ADDENDUM NO. 1
May 2, 2025

2024D Wood Street Improvements – RFP 2025-004
PID: CIPTR-2024D

SHEET NO.
C08

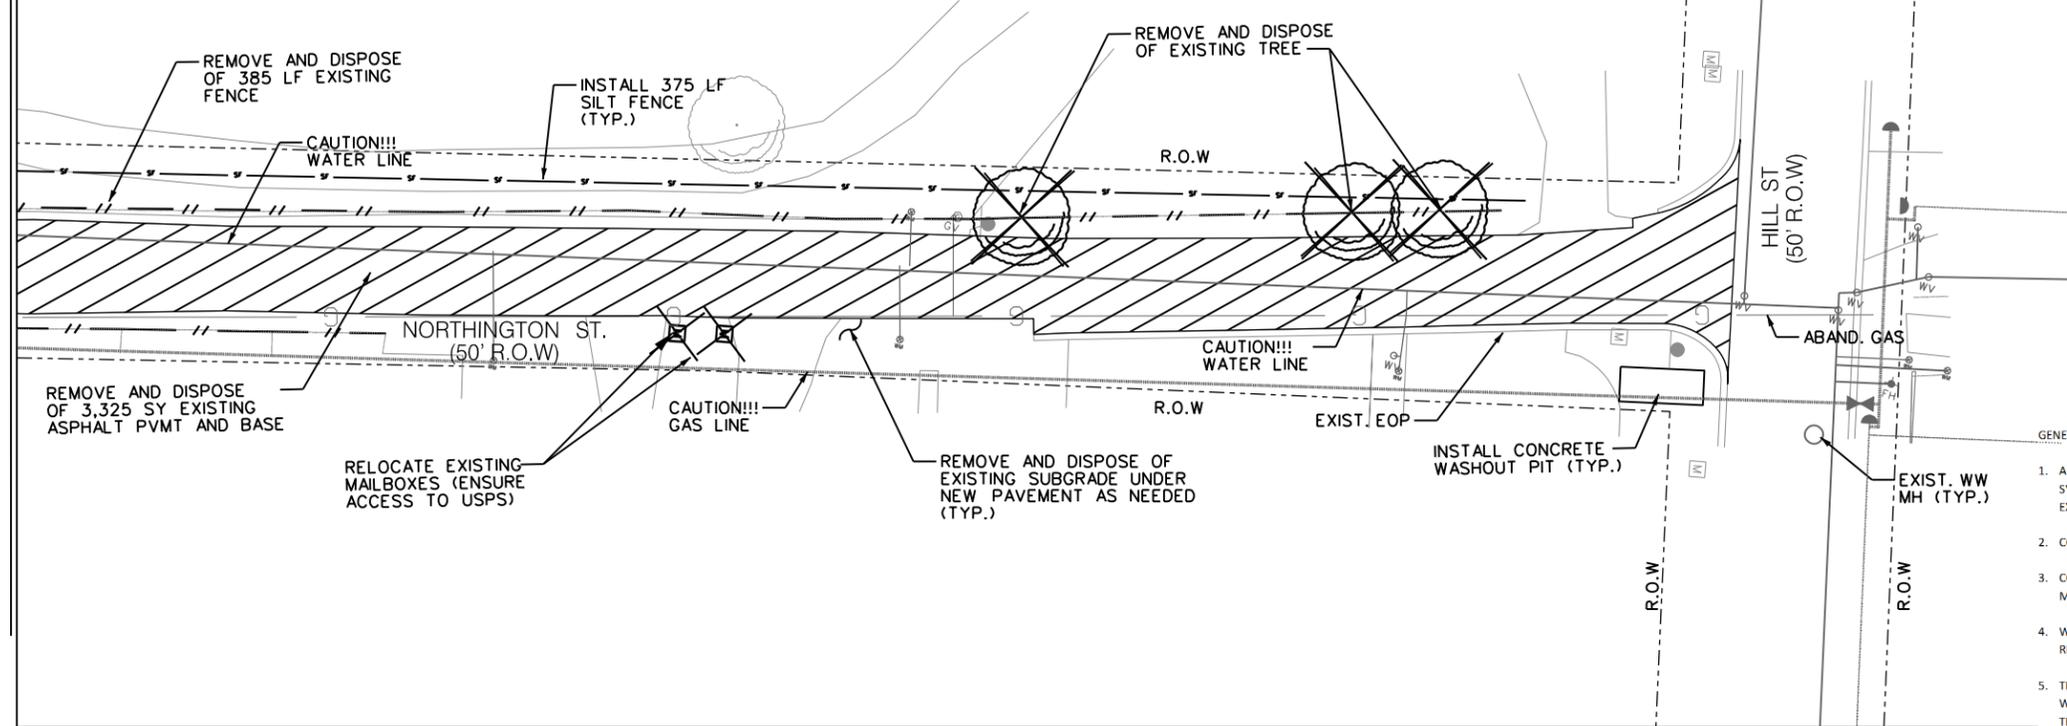
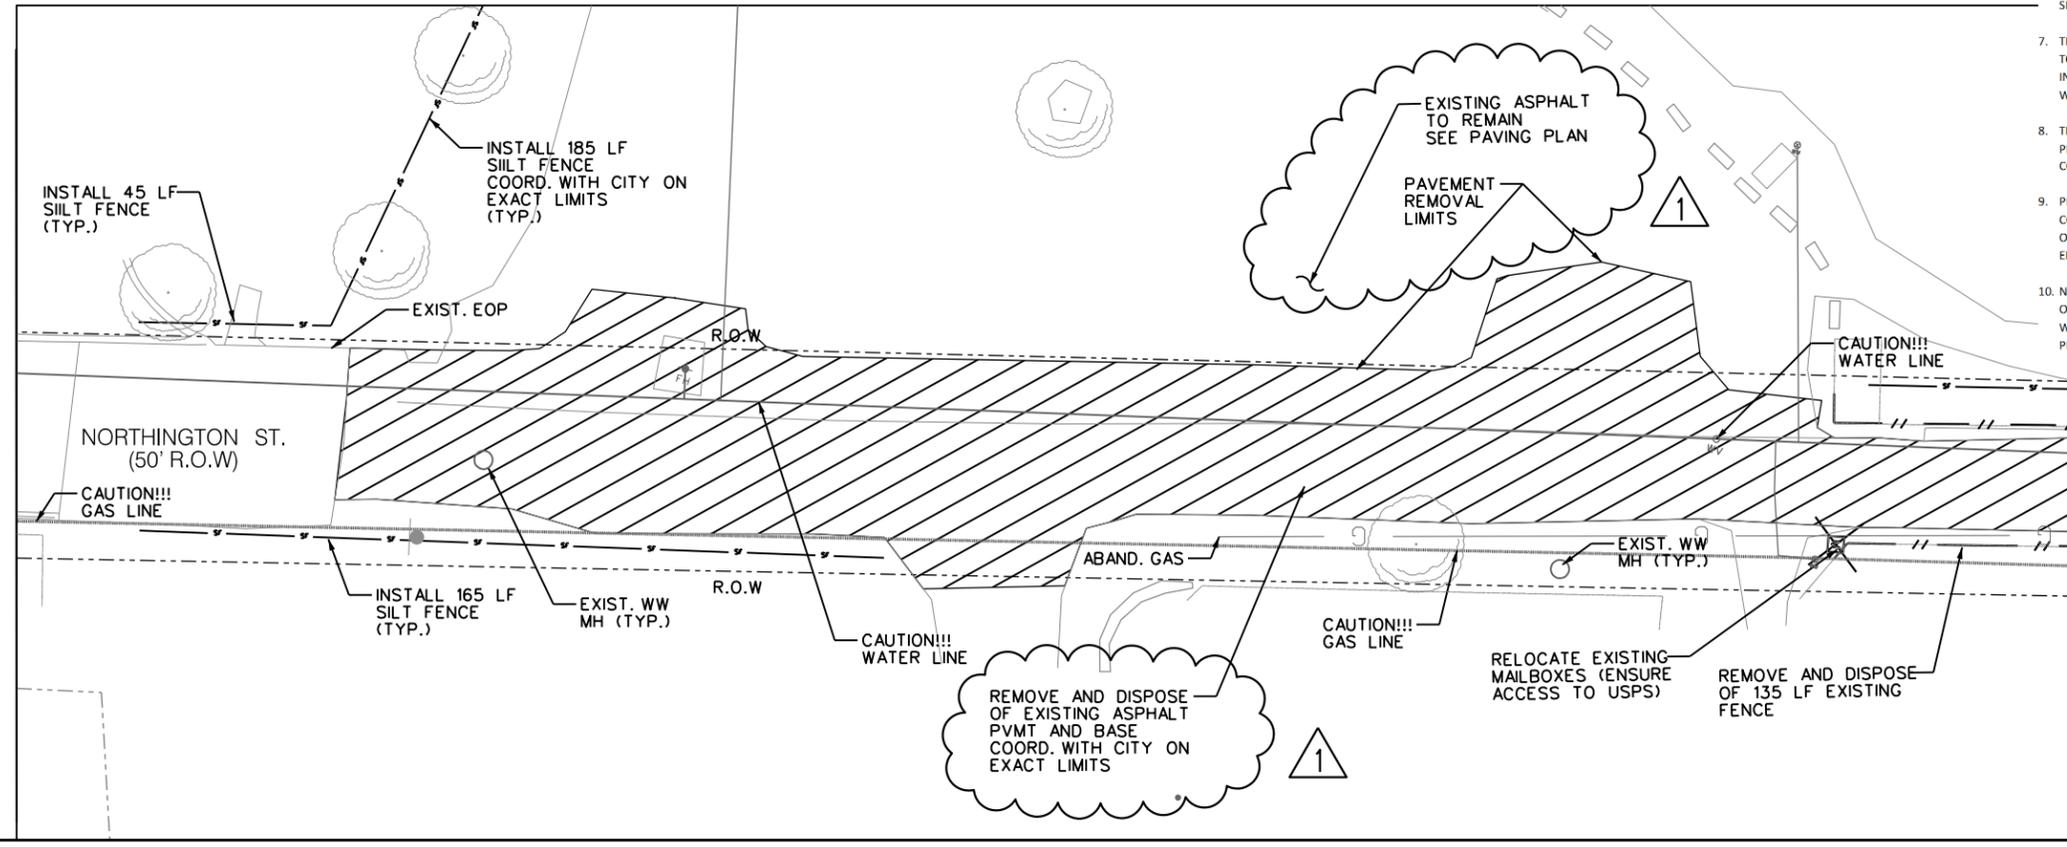
1. **Bonds**: No Change
2. **Dates**: No Change
3. **Questions and Answers**: This Bid Addendum also answers questions posed by contractors throughout the bid process and at the pre-bid meeting as follows:
 - a. *Question from Bidder. See CIVAST*
 - a. Answer. See CivCast
4. **Bid Document Changes**: This item outlines changes to the Bid Documents. Attached are updated bid tab and updated set of drawings:
 - a) This addendum revises a demolition drawing for Northington Drive.
 - b) Updated and Removed previously labeled Bid Tab items 79 to 84 and item 96. Relabeled mislabeled pay `item numbers, affecting most items.Refer to the attached documents.
